HISTORIC AND DESIGN REVIEW COMMISSION

January 18, 2023

HDRC CASE NO: 2022-592
ADDRESS: 1602 N MAIN AVE
LEGAL DESCRIPTION: NCB 1749 BLK 11 LOT S 100 FT OF 1 & W 26.9 FT OF S 100 FT OF 2
ZONING: C-2 CD, H
CITY COUNCIL DIST.: 1
DISTRICT: Tobin Hill Historic District
APPLICANT: Jesse Tavitas/Let's Be Honest
OWNER: Matin Tabbakh/MMAY PROPERTIES LP
TYPE OF WORK: Additions, construction of a canopy, exterior modifications
APPLICATION RECEIVED: December 12, 2022
60-DAY REVIEW: Not applicable due to City Council Emergency Orders
CASE MANAGER: Edward Hall

RENOVATION AND ADDITION TO LET'S BE HONEST BAR AND TAVERN

BUILDING EXTERIOR
ELEVATIONS
SHEET NO.

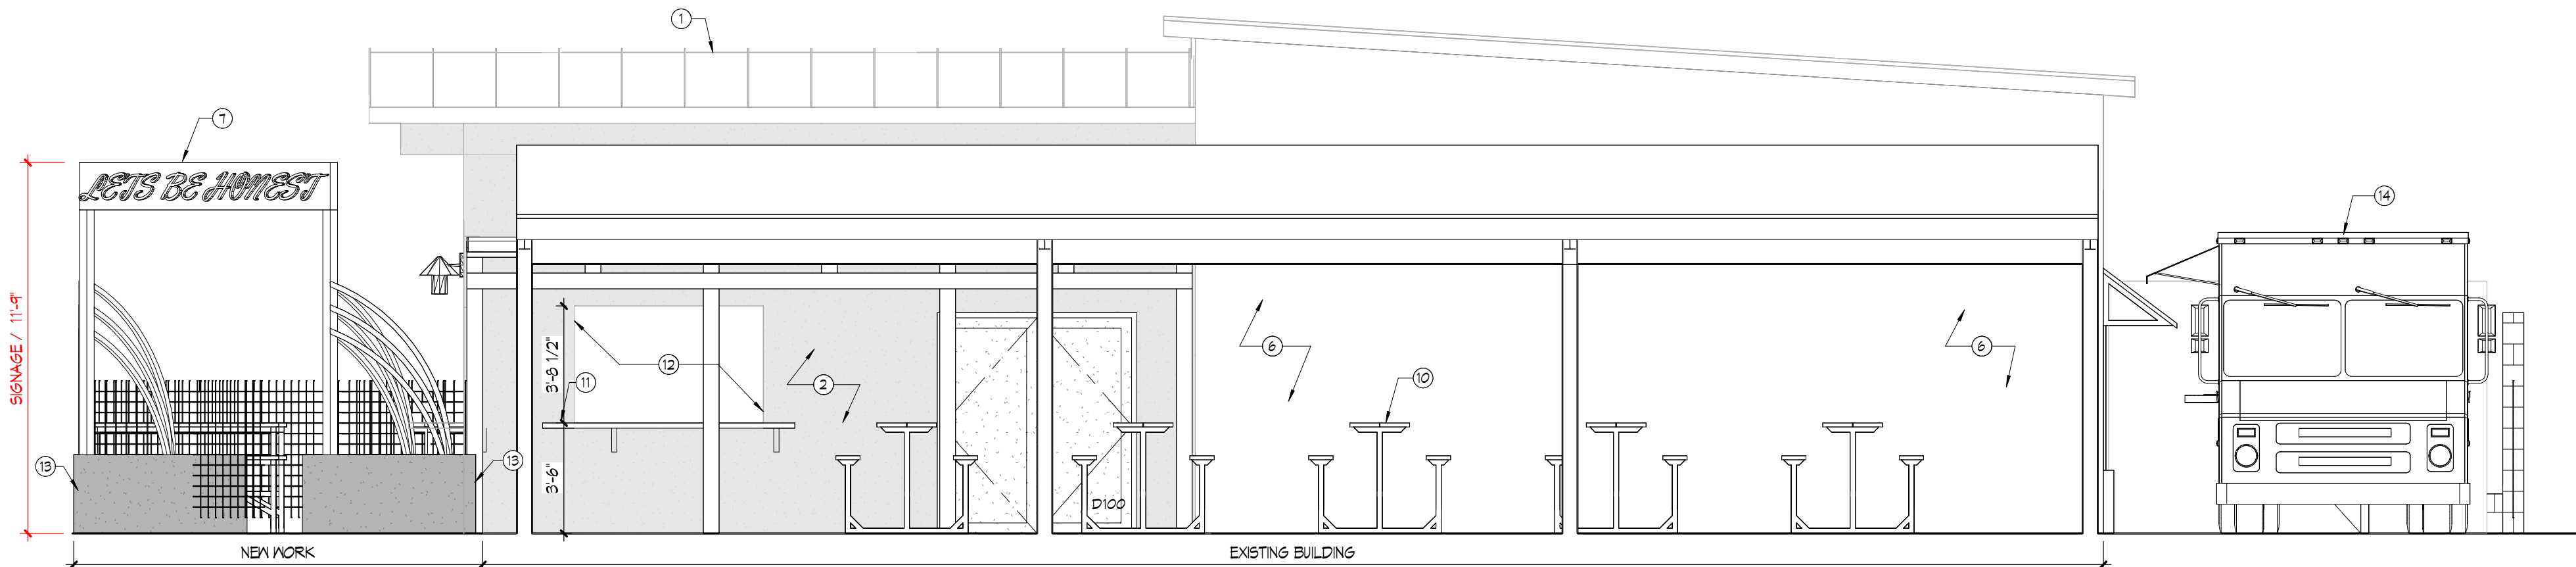
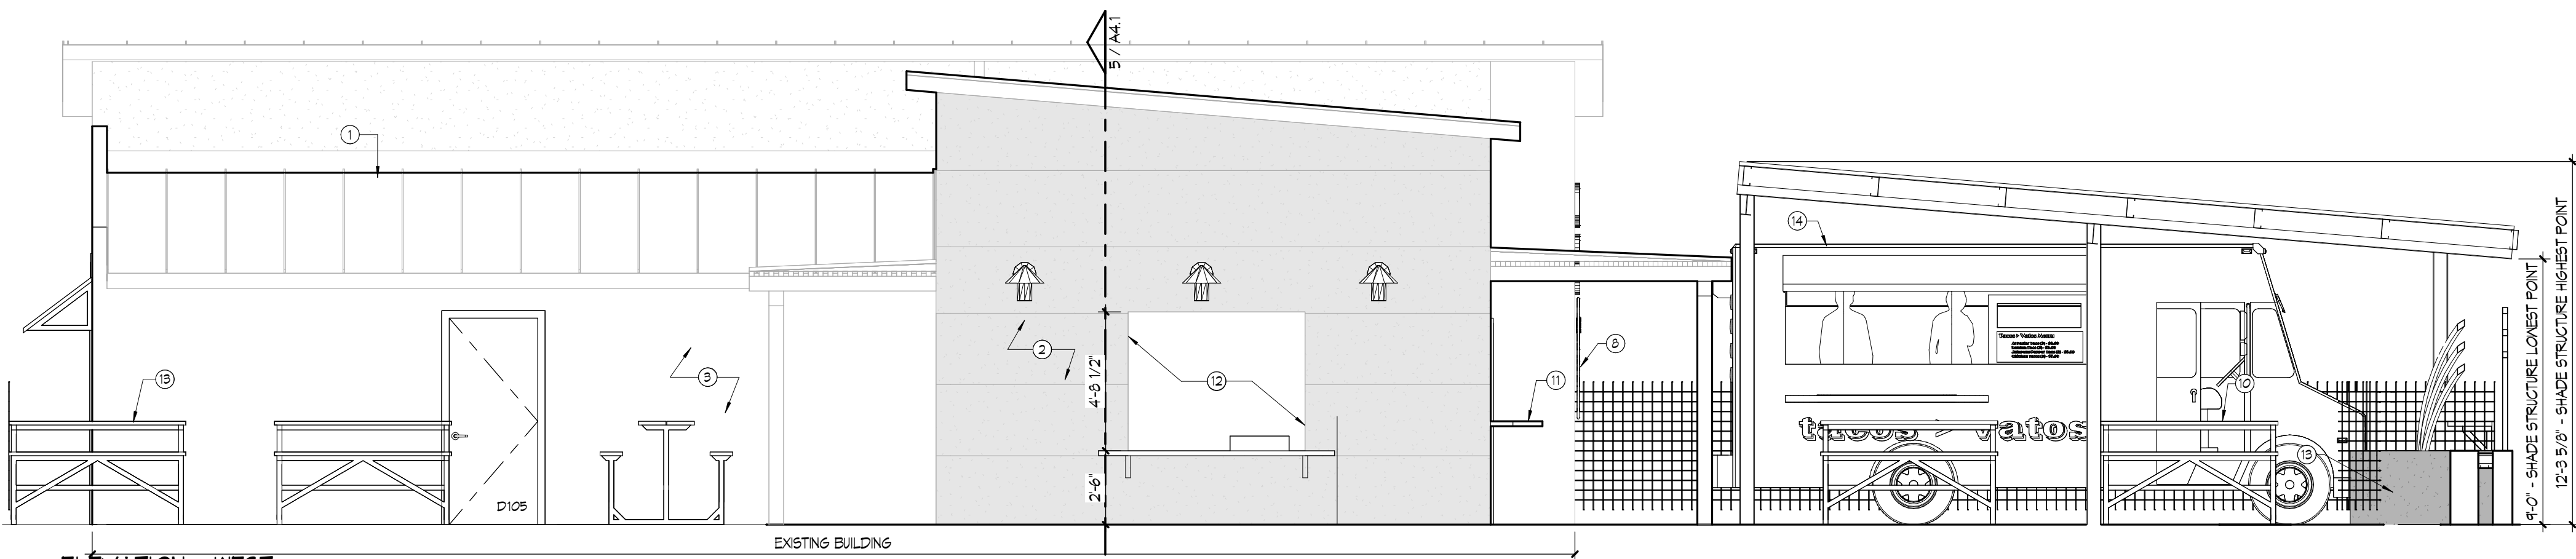
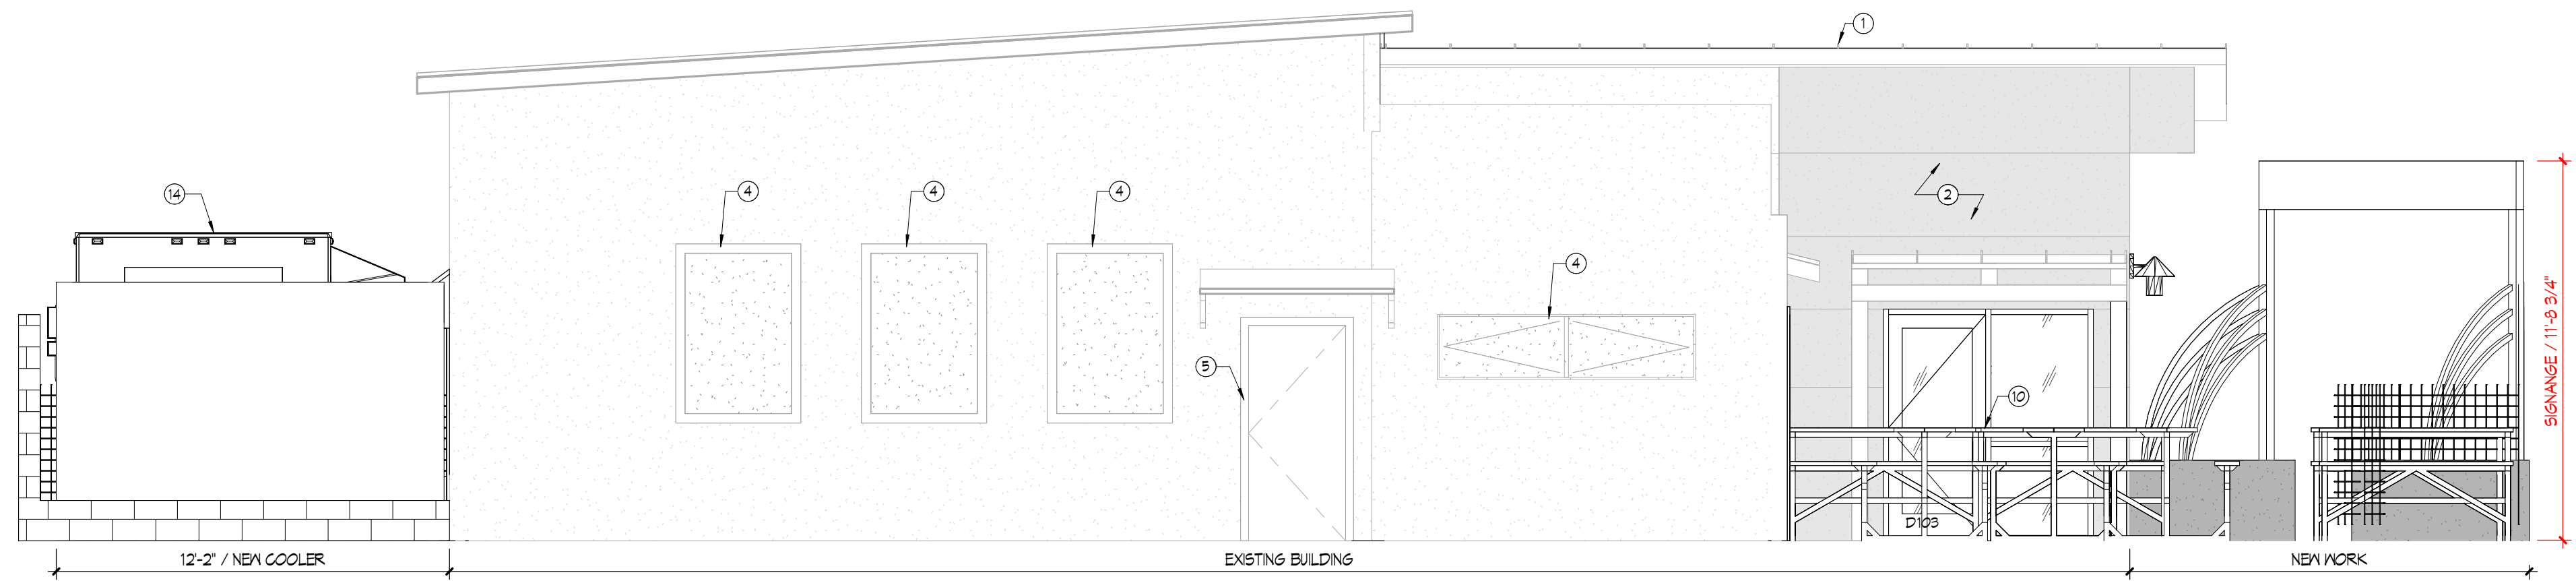
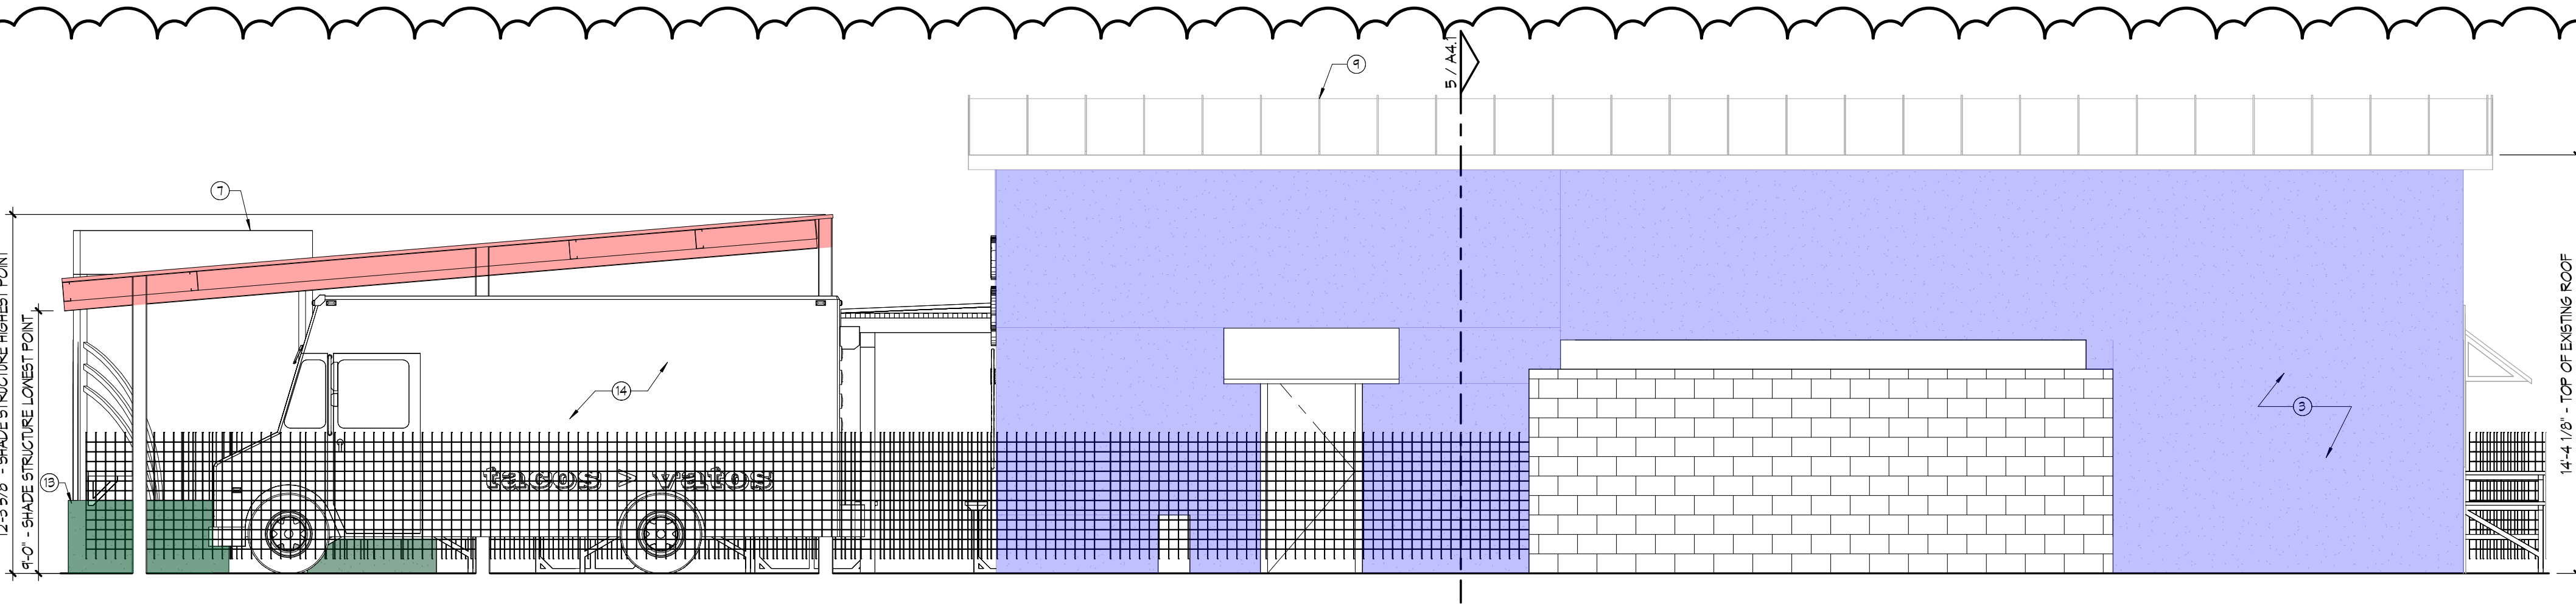
- b. EXTERIOR MODIFICATIONS – The applicant has proposed to perform exterior modifications to the existing structure including creating two new serving window openings; installing a new, R-Panel roof; painting; and applying new finishes to exterior walls. Generally, staff finds the proposed modifications to be appropriate as the proposed roofing will be replaced in-kind and the new window openings will be consistent with the structure's architectural style. Staff finds that the final façade colors and finishes should be submitted to OHP staff for review and approval. Additionally, staff finds that window product specifications should be submitted for review and approval. Windows should match the existing on-site regarding profile, materials and installation depth.

- d. MATERIALS – The applicant has specified that the walk-in cooler will be screened by CMU walls that will feature a stucco finish. Staff finds this to be appropriate; however, staff finds that the proposed stucco should feature a smooth finish and should not appear lumpy.

- e. COVERED PATIO – The applicant has proposed to construct a covered patio structure on the south side of the property, parallel to E Park Avenue. The proposed patio will feature an open-air seating element, steel columns and a shed roof. Generally, staff finds the proposed patio structure to be appropriate. Staff finds that the structure should be painted to match other surfaces on site and that the roofing material should match the predominant roofing material on site.

1. Staff recommends approval of item #1, exterior modifications to the existing structure including creating new window openings, installing a new metal roof, painting, and applying new finishes to exterior walls, with the following stipulations:
 - i. That the proposed R-Panel roofing match the existing R-Panel roofing on site.
 - ii. That the applicant submit final paint colors and façade finishes to OHP staff for review and approval.

- iii. That all new windows match the existing on site regarding profile, materials and installation depth.
Window specifications are to be submitted to OHP staff for review and approval.

- 2. Staff recommends approval of item #2, the installation of a walk-in cooler based on findings c and d with the following stipulations:
 - i. That a stucco finish to match the existing structure's façade material would be most appropriate and consistent with the Guidelines.

- 3. Staff recommends approval of item #3, the construction of a covered patio with the following stipulations:
 - i. That the structure be painted to match other surfaces on site and that the roofing material should match the predominant roofing material on site.

6 FENCE
3/8" = 1'-0"

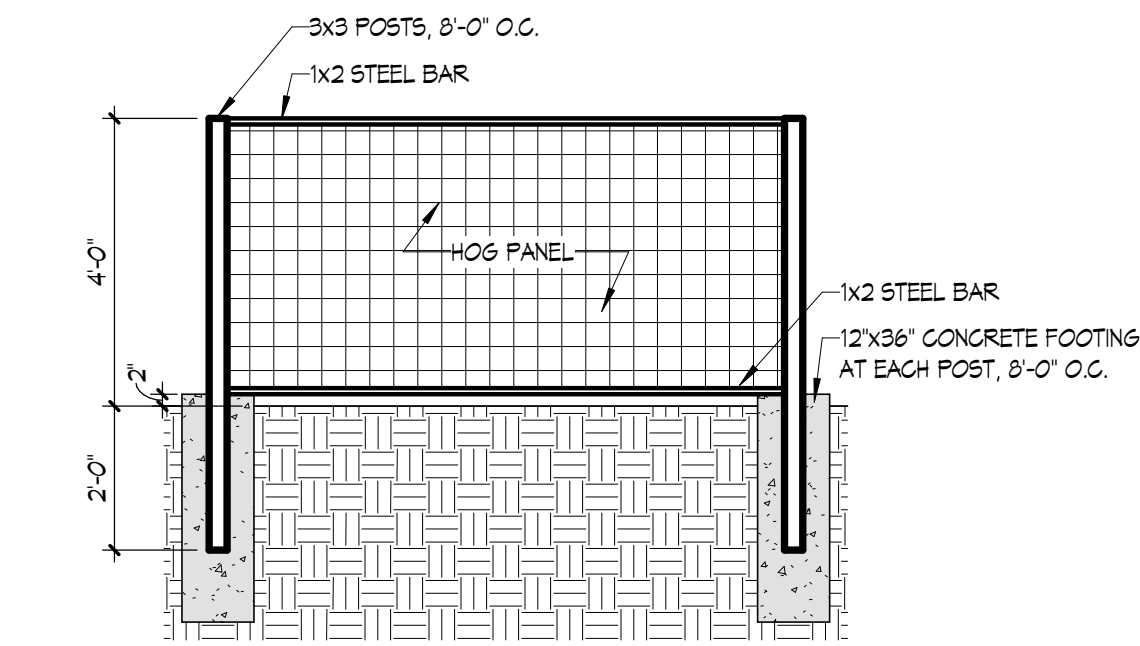
- f. FENCING & OUTDOOR SEATING – The applicant has proposed install fencing and outdoor seating on the west side of the property, parallel to N Main. The proposed seating elements will contain CMU planters. Generally, staff finds this to be appropriate; however, staff finds that a fencing detail should be submitted for review and approval. Fencing elements should not exceed four (4) feet in height.

- 4. Staff recommends approval of item #4, the installation of outdoor seating and fencing, based on finding f with the following stipulations:
 - i. That a fencing detail be submitted for review and approval.

- ii. That fencing not exceed four (4) feet in height and remain predominately open in design.
